**From:** Tomkins, James [jjetomkins@STPEGS.COM]  
**Sent:** Tuesday, December 28, 2010 9:46 AM  
**To:** Joseph, Stacy  
**Subject:** RE: Draft 6C R1 Uploaded  
**Attachments:** Appendix 6C Markup draft R1.pdf

## 6C Containment Debris Protection for ECCS Strainers

STD DEP 6C-1 (Figure 6C-1, ~~6C-2, 6C-3, 6C-4, and 6C-5~~)

Figure 6C-2 Core Inlet Delta P for Blocked and Unblocked Cases

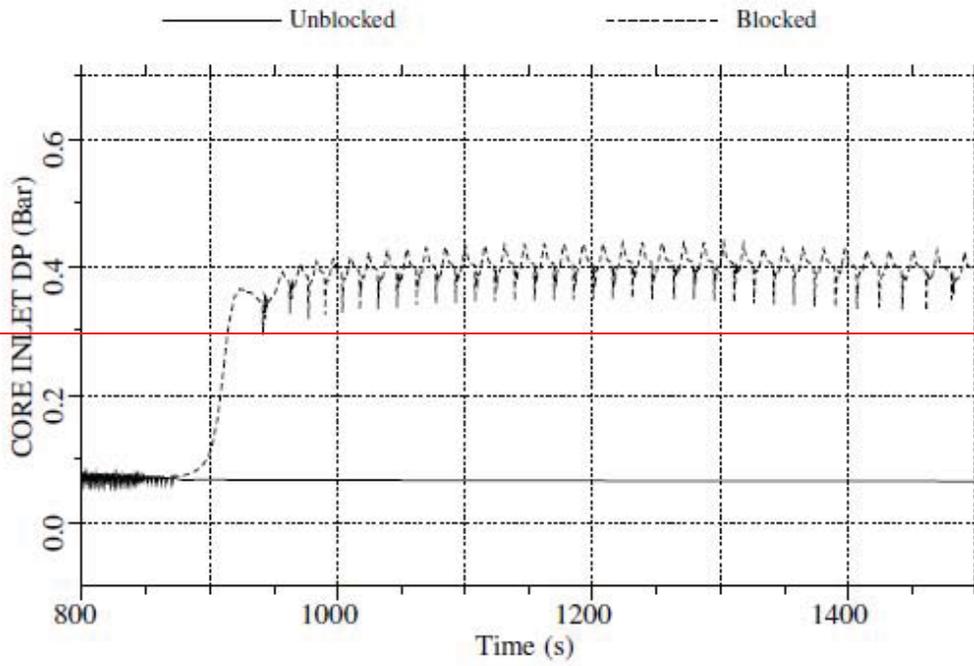
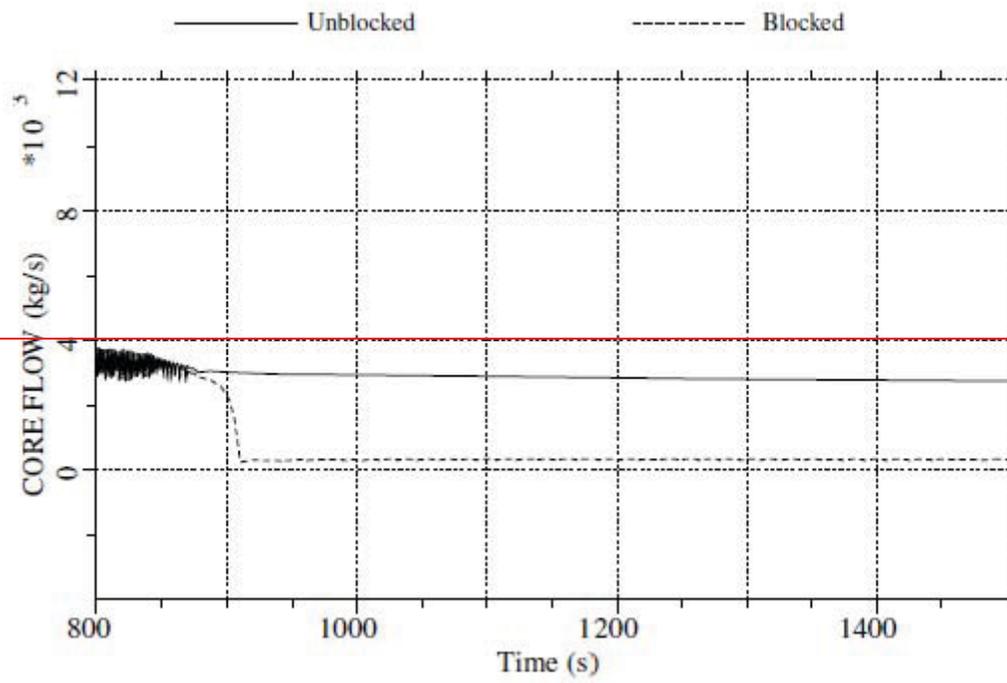
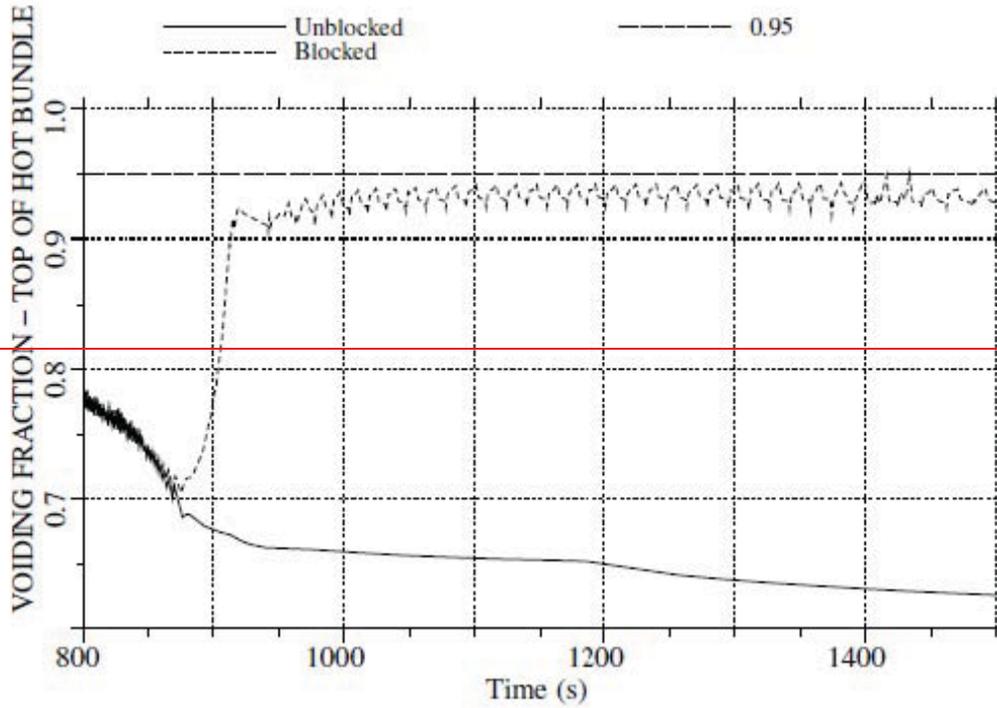
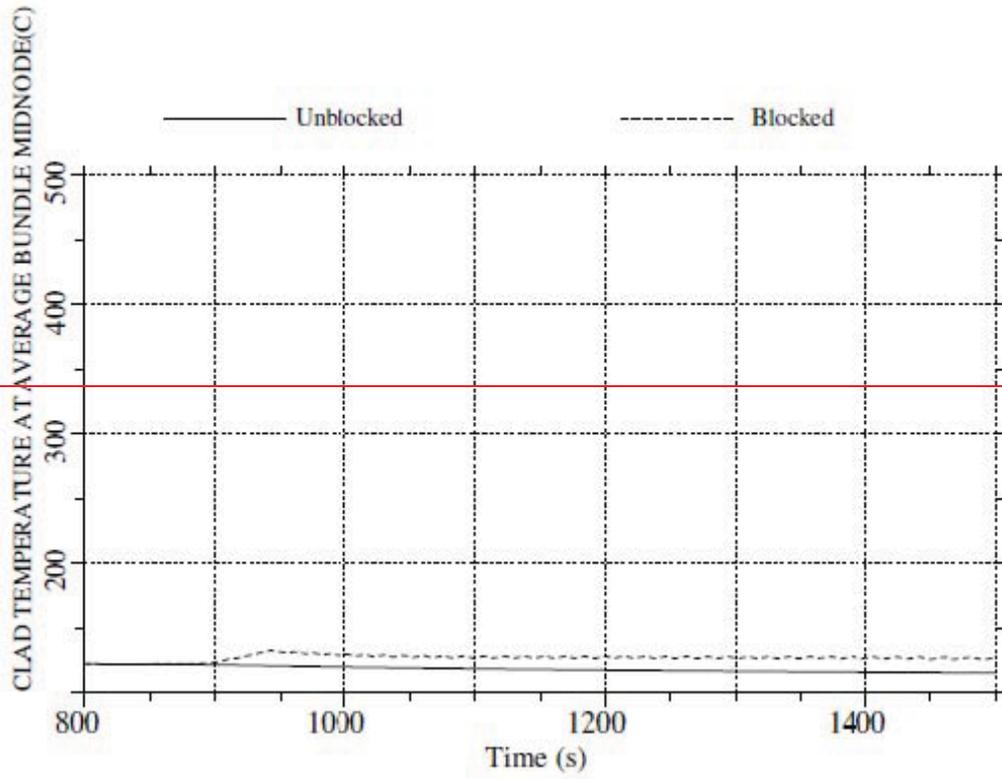
Figures 6C-2, 6C-3, and 6C-4 Analysis was performed to compare the core inlet DP, flow rate and void fractions for the cases with no blockage and with blockage resulting in a reduction of flow area by 90% of inlet flow area an increase of the hydraulic resistance of the fuel inlet. Five minutes is the estimated amount of time required for debris in the containment to start to reach the fuel filters. The models assume clogging begins at 850 seconds because that is when the flow through the core reaches steady state. In order to ensure any effects seen are covered by the changes being made, steady state flow is required. Despite a very high level of blockage hydraulic resistance, sufficient flow
